RAMPUR HYDRO POWER STATION (412 MW)

No.: SJVN/RHPS/ F-10/504

Subject: Diversion of 0.8374 hac of forest land in favour of Rampur Hydro Electric Project, SJVN Limited, VPO Jhakri, Rampur Bushahr, Distt. Shimla (H.P.) for the construction of river training, road & road protection etc. within the jurisdiction of Rampur Forest Division, Distt Shimla, H.P.- Clarification / compliance to the observations thereof.

Reference is drawn to letter no.3736, dated 21/09/2015, vide which observations in respect of the subjected matter were made by Nodal Officer cum – Addl. Pr. CCF (FCA), Shimla (H.P). Point wise clarification / compliance is provided here as under:

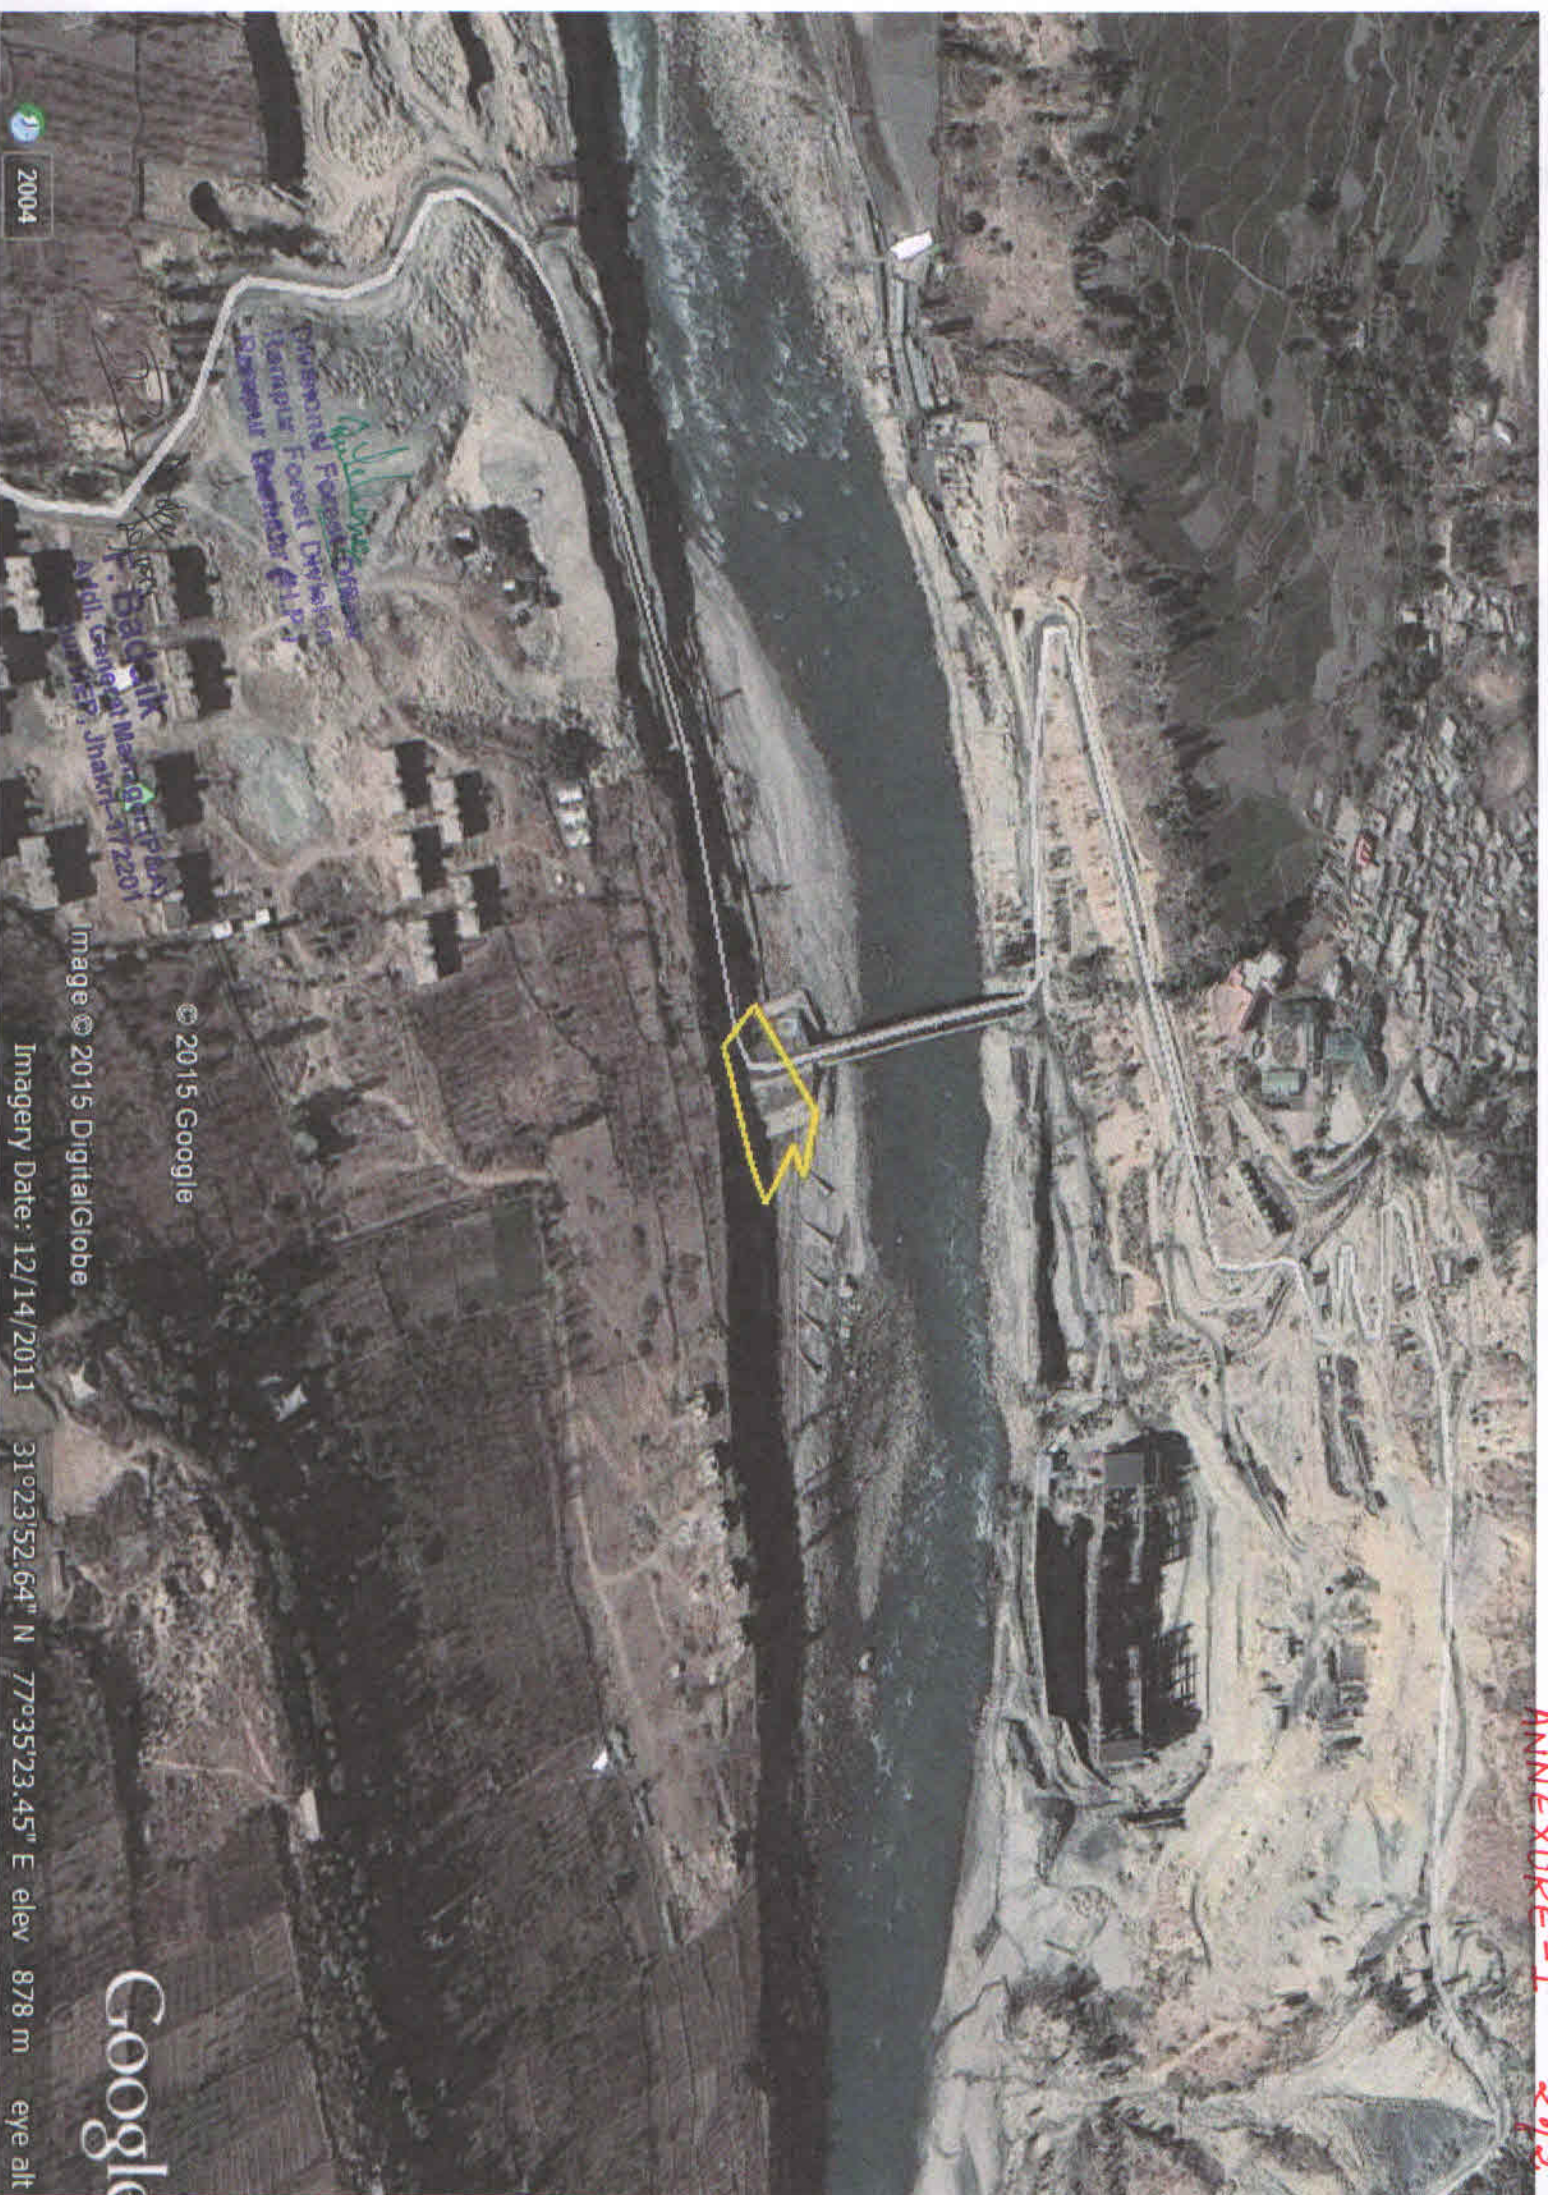
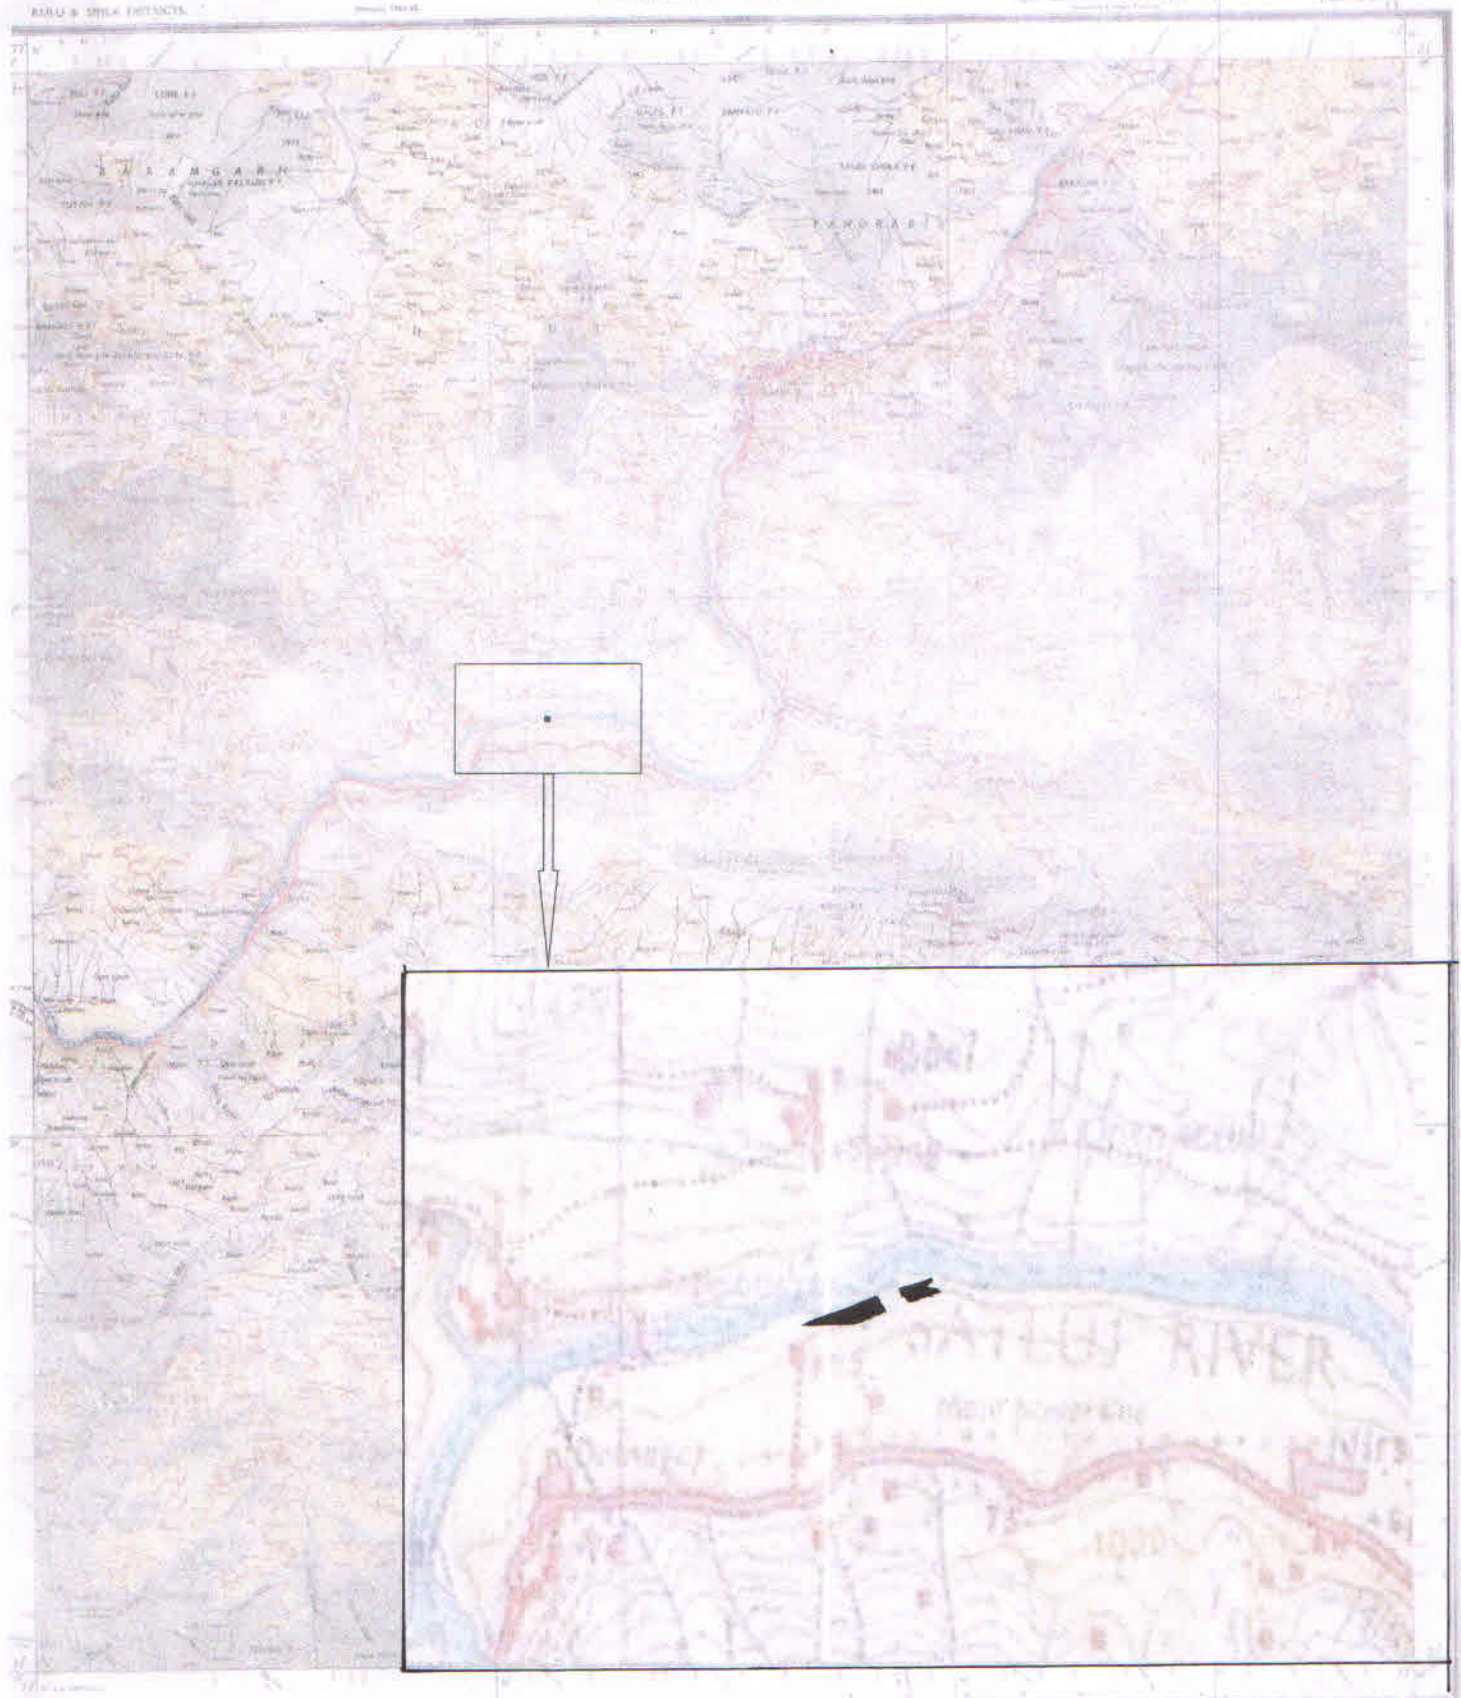
2.	Area proposed for diversion not properly marked on Sol Toposheet attached in Part 1.	Area proposed for diversion magnified and conspicuously marked to shape at Annexure-2 .

Digital Map of Compensatory Afforestation Site Rampur Hydro Electric Project (412 MW)

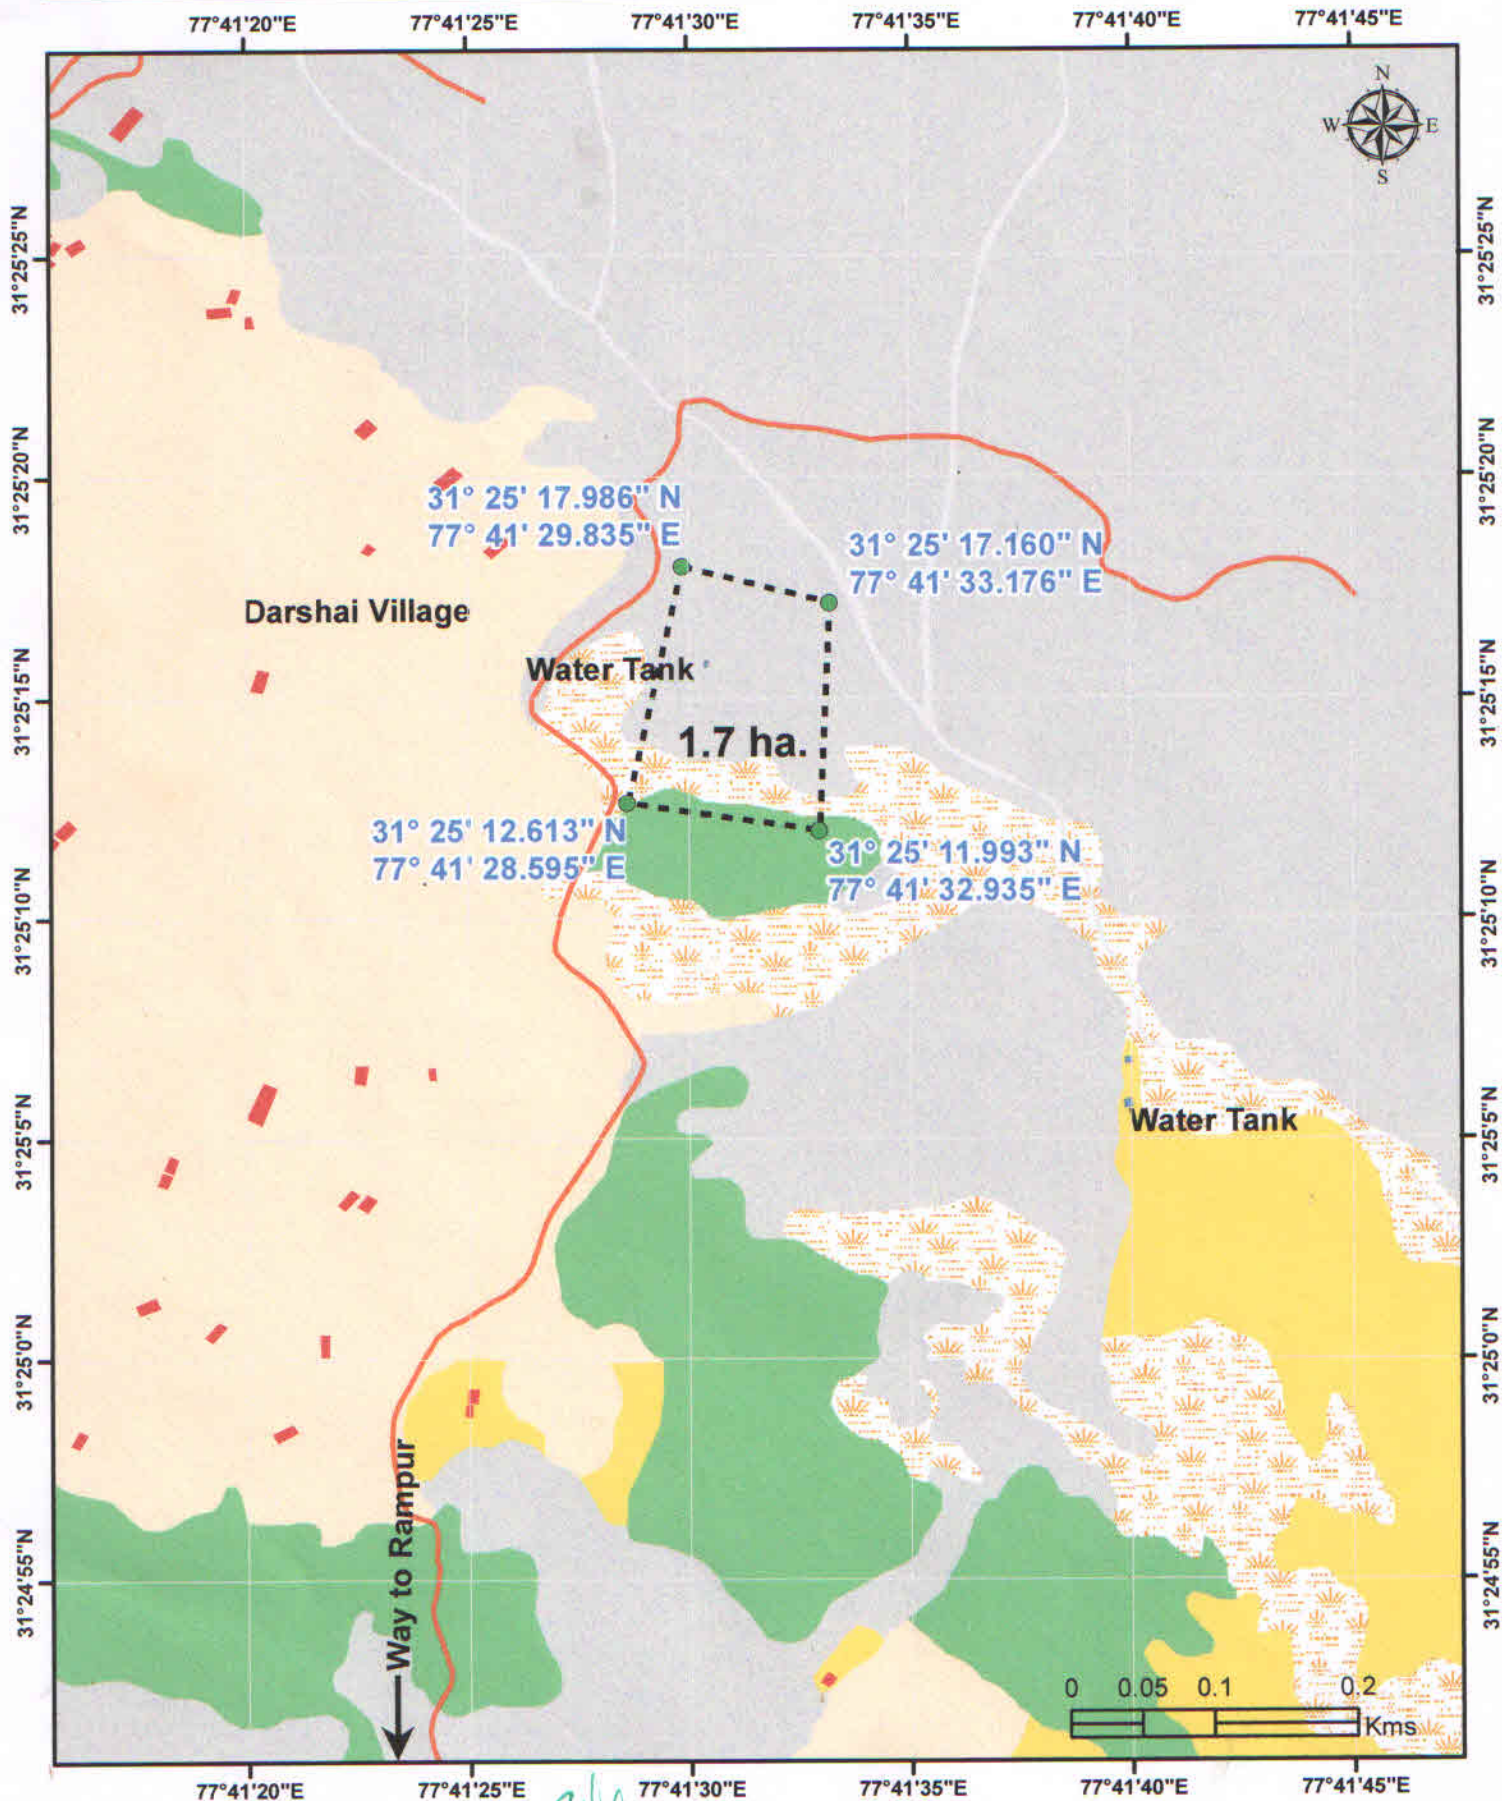
7.	CA Scheme not uploaded properly and could not be opened. May upload again.	Pertains to Forest Department.
8.	Digital Map of area proposed for CA giving geo coordinates at minimum 4 points in hard and soft copy duly authenticated by DFO not provided.	Digital Map of CA area authenticated by DFO enclosed as Annexure-3 .
